Western Sydney Green Gas Project - Response to Submissions

Jemena Gas Networks (NSW) Limited

Project Name	Western Sydney Green Gas Project - Response to Submissions
Project Number	19SYD - 13511
Project Manager	Daniel Magdi
Prepared by	Rebecca Ben-Haim
Reviewed by	Daniel Magdi
Approved by	Daniel Magdi
Status	Final
Version Number	2
Last saved on	1 May 2020

Figure 1: Horsley Park Master Plan (2019)

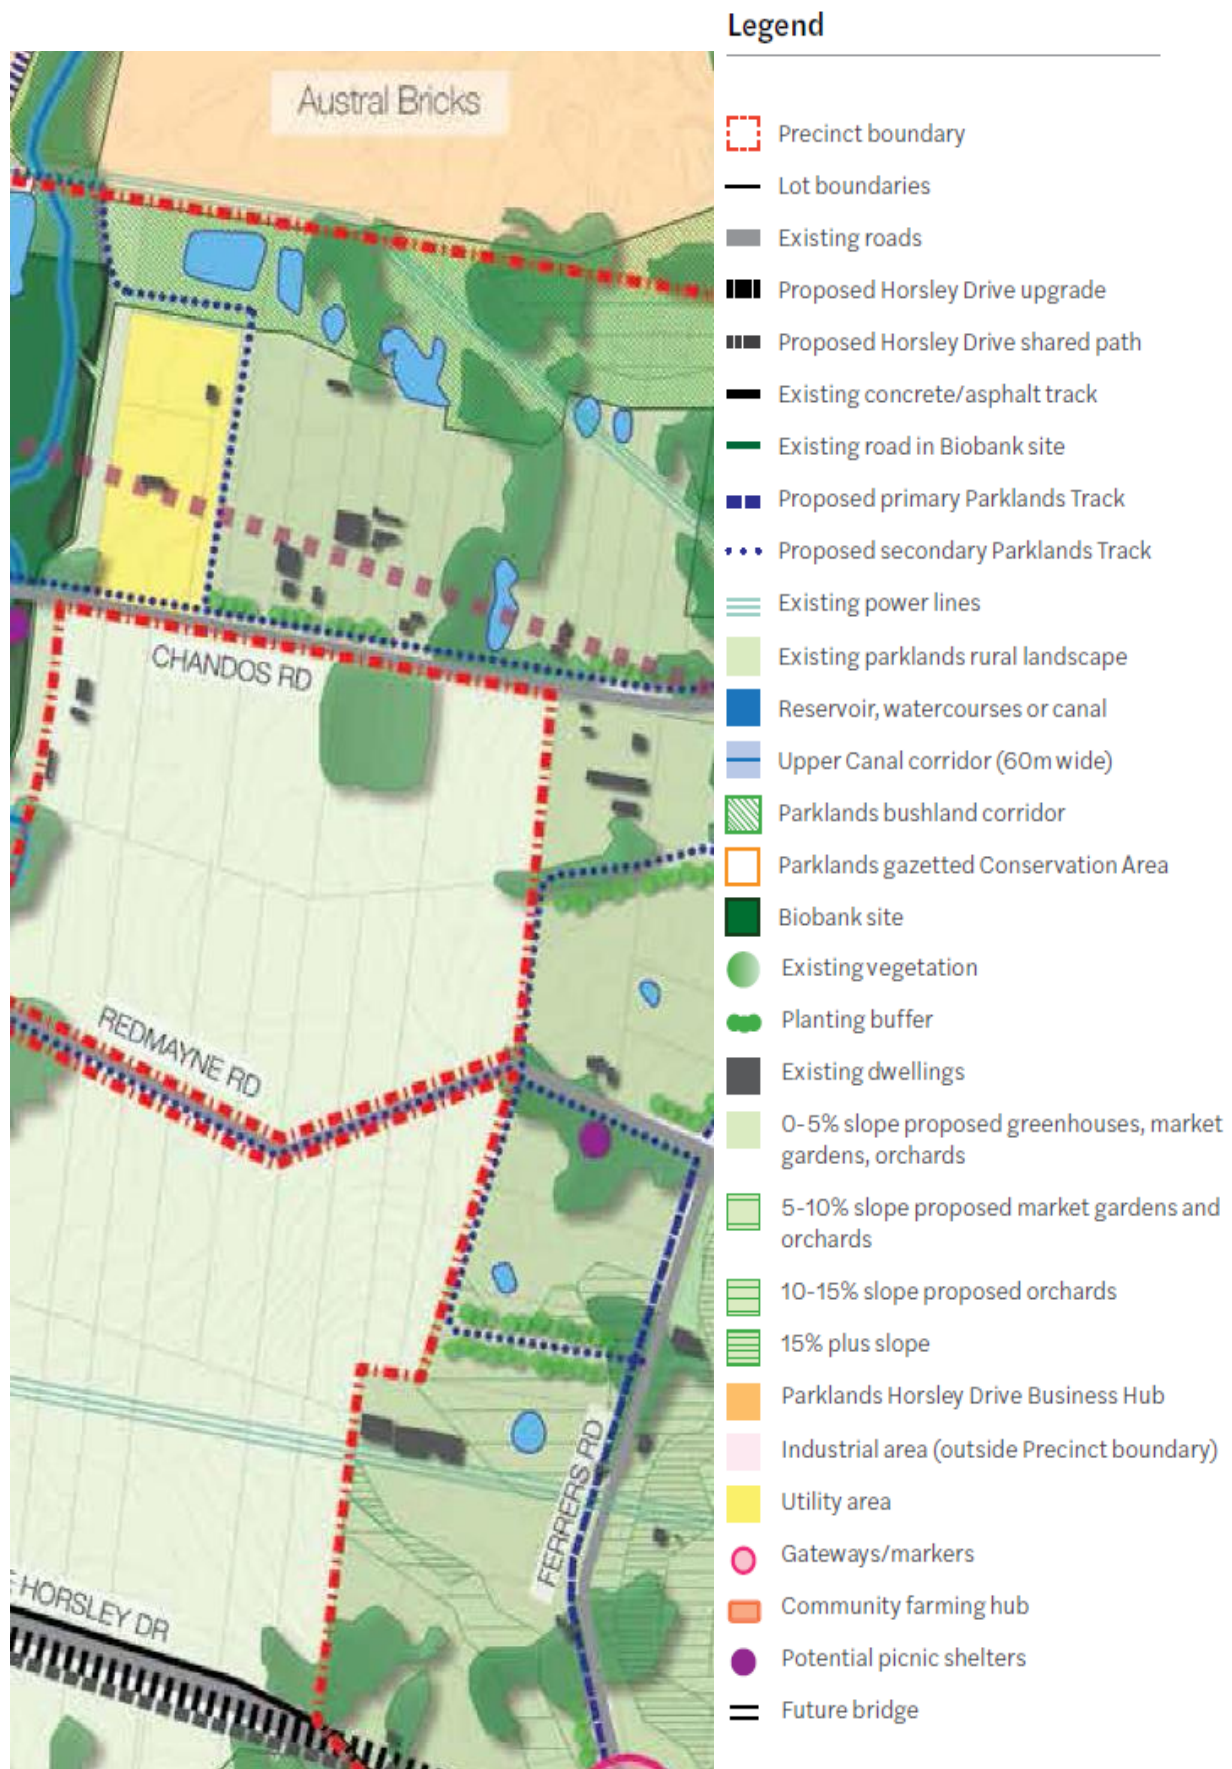
As raised in previous correspondence and meetings with Jemena the safe operation of the proposed facility is essential. This is particularly important with the proposed public walking tracks intended to be directly north, east and south of the property, as outlined in the *Horsley Park Urban Farming Masterplan 2019*.

In accordance with the Horsley Park Master Plan, a secondary parklands track is proposed in proximity to the north, east and south boundaries of the WSGG Project site (Figure 1 and Figure 2). It is acknowledged that all proposed tracks are to conform with the WSPT's Parkland Design Manual.

The secondary parklands track is proposed to be situated approximately 50 m east of the HRS (Figure 2). The location of the secondary parklands track has been examined against the findings of the Preliminary Hazard Assessment (PHA), Section 7.3 and Appendix C of the WSGG Project EIS (ELA, 2019), and as such the secondary parklands track will be within the radiation contour as defined within the PHA.

Whilst the HRS is included within the current WSGG Project description, further viability assessments of the HRS will be undertaken and there is currently no certainty that the HRS will eventuate. Given this, Jemena will commit to an additional hazard assessment to reassess the risk to the secondary parklands track if the HRS is determined to be viable and proceeds. The additional hazard assessment would include considerations of additional mitigation measures if required.

Figure 3: Mainstream Flood with 100 year ARI flood contours (Lot 1 DP 499001)

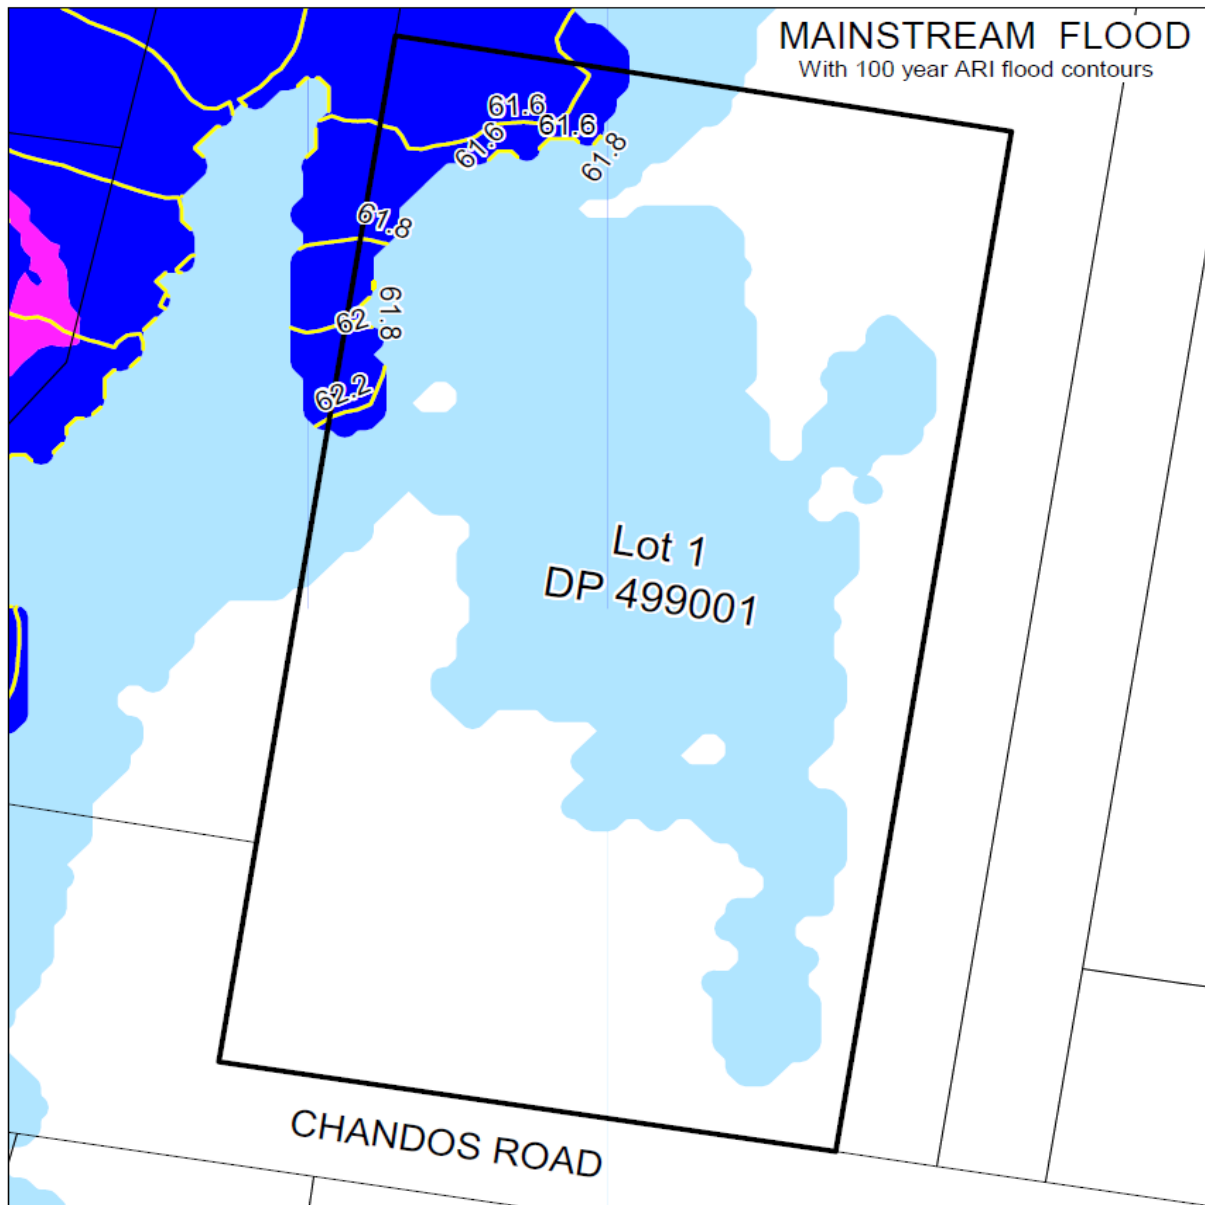
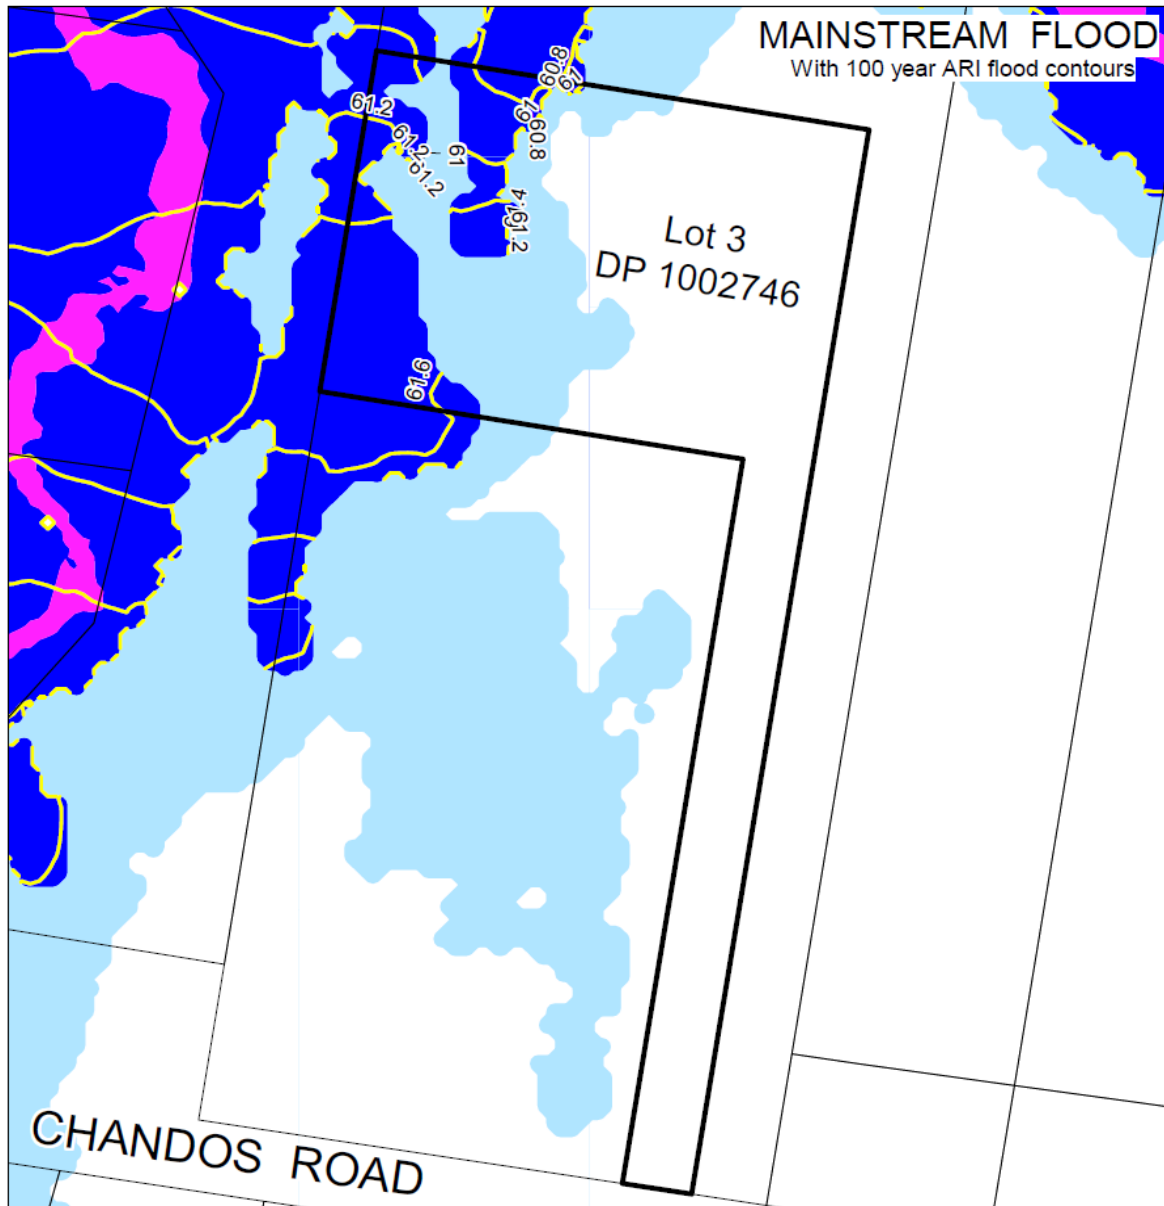
Flooding – In Council's letter dated 14 May 2019 the applicant was advised to apply for a section 10.7 (2) and 10.7 (5) planning certificate prior to preparation of the EIS. This is important as it allows flooding to be properly addressed. The applicant did not do this. Therefore, the EIS does not address flooding accurately.

flood map which will show flood risk precincts across the entire site. This should be overlaid with the proposed works location to show the proposed works are outside the floodplain.

A Section 10.7 planning certificate has now been obtained and states in it the relevant flood levels for the PMF, 1 in 100 ARI and 1 in 20 ARI events, noting that the flood levels have been duplicated between the 1 in 20 and 1 in 100 ARI events for Lot 3 DP 1002746. As per the advice within the 10.7 planning certificate, flood maps were sought from Council (Figure 3 and Figure 4).

The levels provided in the 10.7 certificate and flood maps show that the area is subject to inundation under a range of flood conditions. Two flood categorisations occur on the sites – Low Flood Risk Precinct and Medium Flood Risk Precinct. The definitions of which, as per the 10.7 planning certificate are:

The proposed P2G facility encroaches upon the low flood risk precinct mapped within Lot 1 DP499001, however this encroachment is very minor, with the majority of the P2G facility outside of the mapped flood zones. As part of detailed design, should any of the works be wholly located within one of the flood zones, as per Figure 3 and Figure 4 below, a flood risk management report will need to be prepared to ensure flood risks are mitigated appropriately.

Figure 1: Location of the Nearest Sensitive Receptors, Prospect Reservoir and Prospect Water filtration Plant

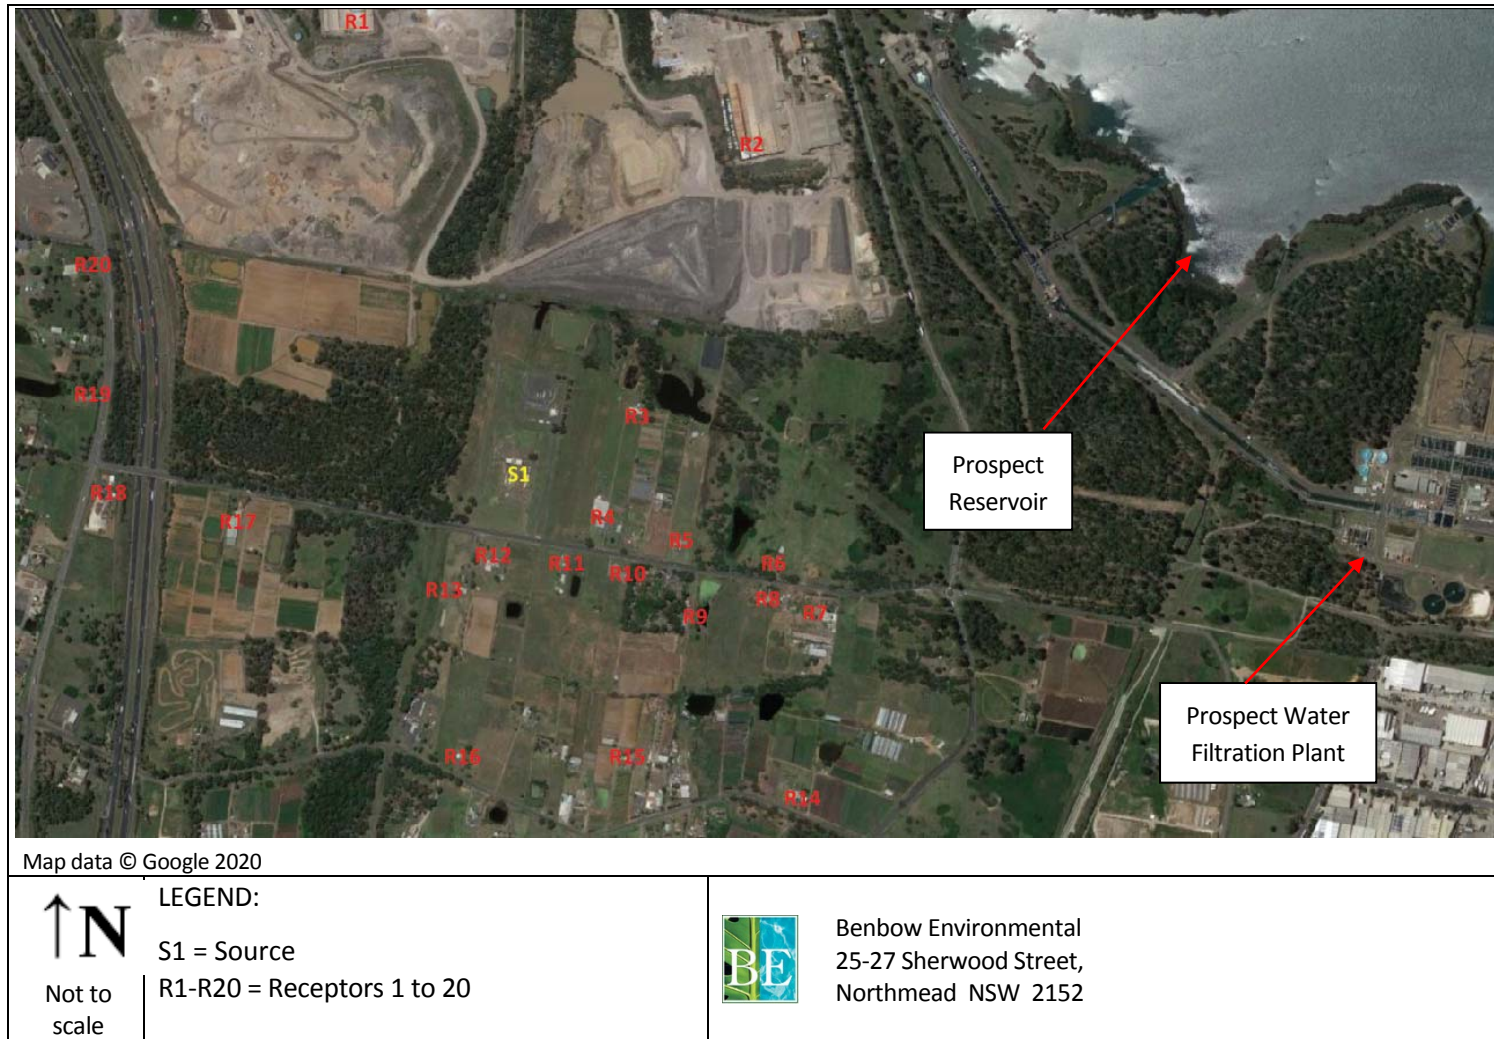
WaterNSW has reviewed the proposal and suggests the applicant consider Prospect Reservoir as a sensitive receiver, with the potential dust and air quality impacts on this sensitive receiver assessed and responded to in the 'Response to Submissions'.

The proposed development is approximately 1.1 km south west of Prospect Reservoir and 1.5km west of the Prospect Water filtration plant. The original assessment considered seven (7) closer sensitive receptors in the direction of Prospect reservoir. The location of Prospect reservoir in context of the proposed development is shown in Figure 1.

There are no sources of dust and particulates associated with the operation of the WSGG Project. However, emissions to air may occur during the construction phase of the project. Recommendations have been made to ensure construction impacts are mitigated. Due to the significant distance between the site Prospect Reservoir and the mitigation measures implemented proposed, dust and particle impacts at Prospect Reservoir from the proposed development would be negligible.
